B Name of Land Development: 210 SUNNYBROOK ROAD

Reference: 210 Sunnybrook Road – Subdivision Application

Re: MCPC # 24-0045-002
Plan Name: 210 Sunnybrook Rd
(2 lots/2du comprising 0.42 acres)
Situat: Sunnybrook Road (E); north of Carolton Way
Springfield Township

MINOR SUBDIVISION PLAN

LOT 2 SEEPAGE PIT DETAIL
 NOT TO SCALE

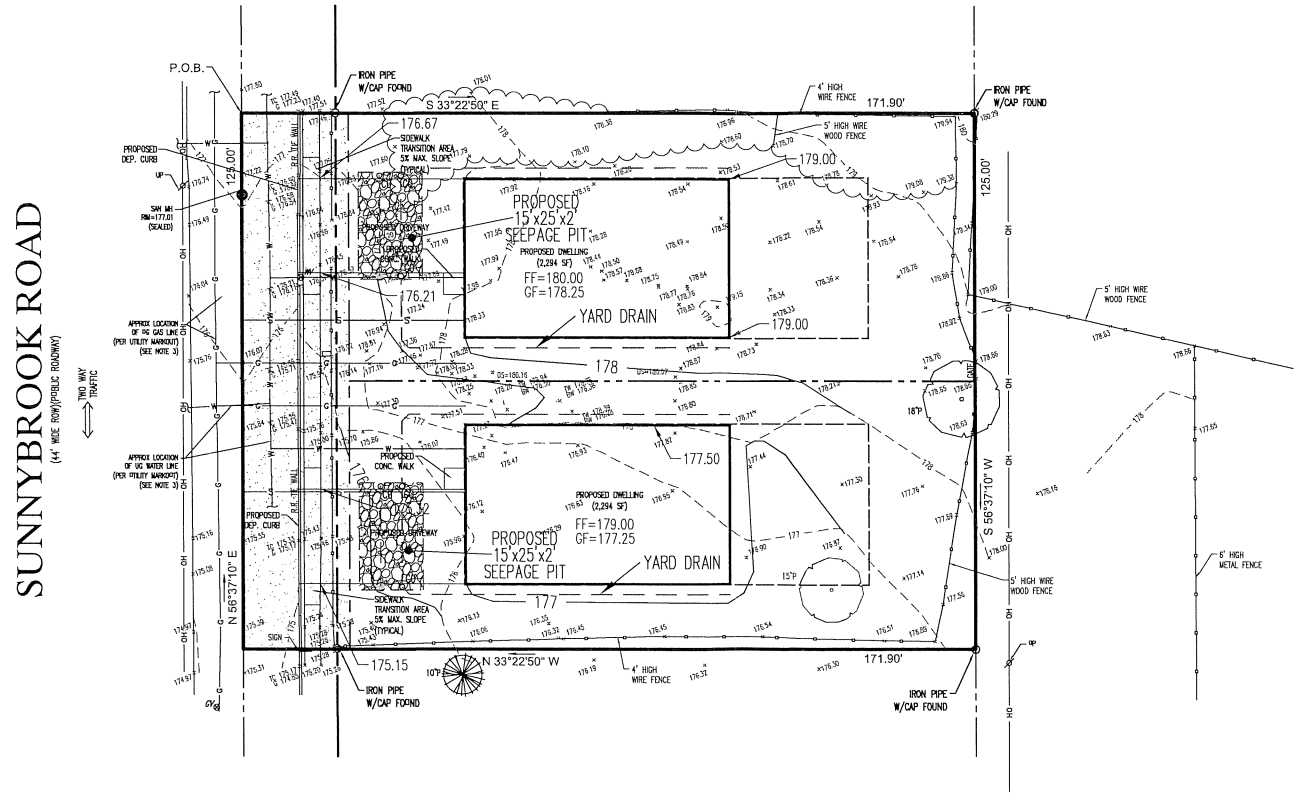
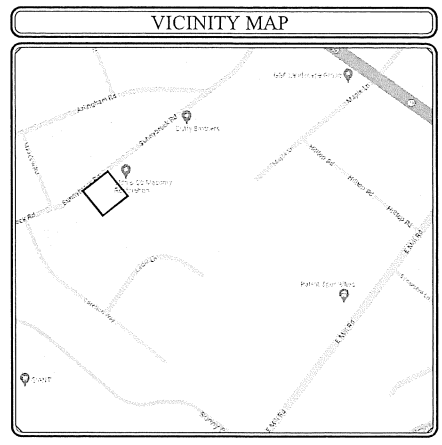
- e. The plan calls for plastic risers to serve as cleanouts for the underground system. These plastic facilities should be replaced with 2' x 2' concrete boxes or long-term stability and function.

- f. The underground seepage beds must be fitted with an overflow that will direct water toward the street as opposed to directing it toward any adjacent properties. It is acknowledged that during severe rain events the capacity of the stone seepage beds will be exceeded and runoff discharge will be expected.

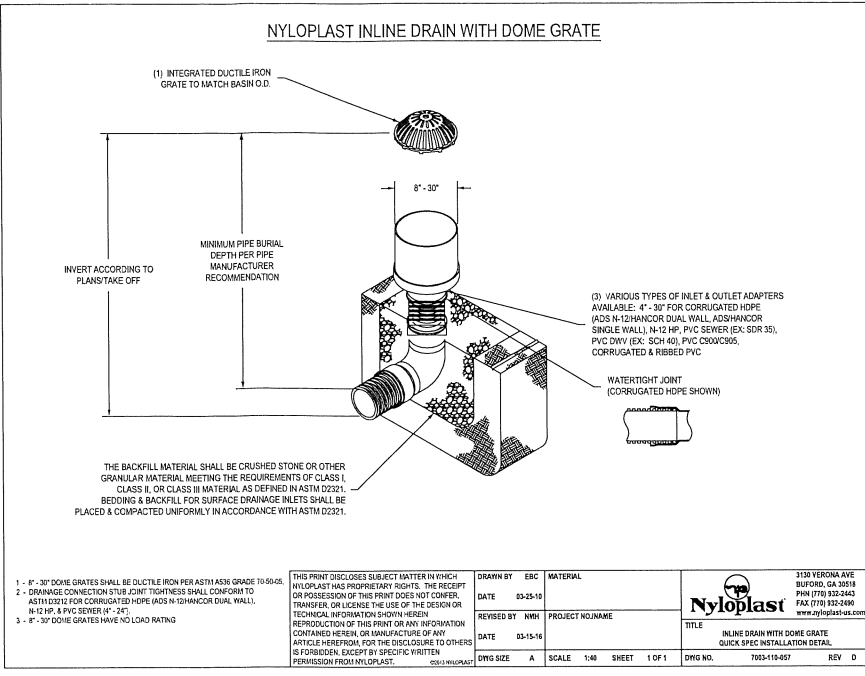
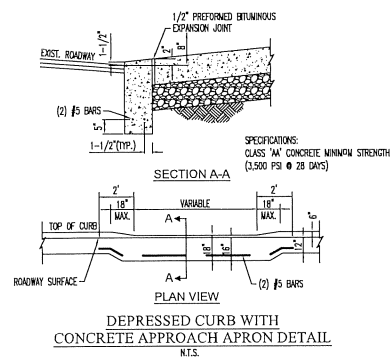
- d. Lot 2 should be fitted with a 2' x 2' concrete inlet box to capture any residual runoff from the rear yards of both Lot One and Lot Two. This inlet box should be connected to the storm sewer system that carries water to the front yard underground seepage bed stormwater facilities.

- h. The site grading plan should be amended to better define a property line swale that separates lot one and lot two
- i. The construction sequence should be clarified to assure that proper soil and erosion control measures are implemented prior to earth disturbance. Further, the “during initial construction” timeframe is most critical for adjacent neighbor issues. All diligence should be implemented to protect the adjacent neighbors.

- j. The plan indicates an obligation to capture rainwater downspouts in a piped drainage system. The plan must provide better details as to the pipe size, pipe material, invert grades and slopes as well as effective clean out location for bends and terminal points.

**STANDARD CONSTRUCTION DETAIL #4-7
STANDARD SILT FENCE (18" HIGH)**

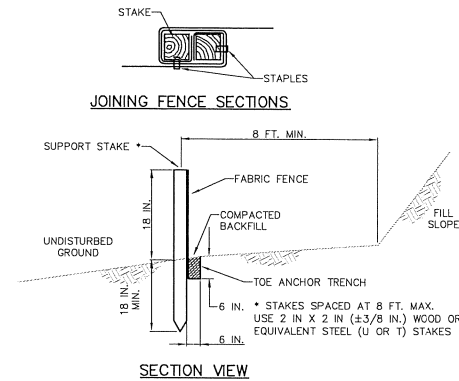
3. Due to the amount of construction disturbance anticipated, concrete sidewalks fronting the property should be replaced with home construction.
4. The plan currently shows detail for silt fence. The industry standard has moved away from fencing and into a silt sock which appears to be more effective means of filtration.
5. A legal description is required for the area of Sunnybrook Road currently encumbered by title and intended to be offered for public dedication.
6. The current site contains various sections of old and ineffective fencing. The plan should speak to the removal and/or replacement of this old fencing.
7. The plan must note obligation to provide as built surveys for the individual homes and stormwater features prior to use and occupancy.
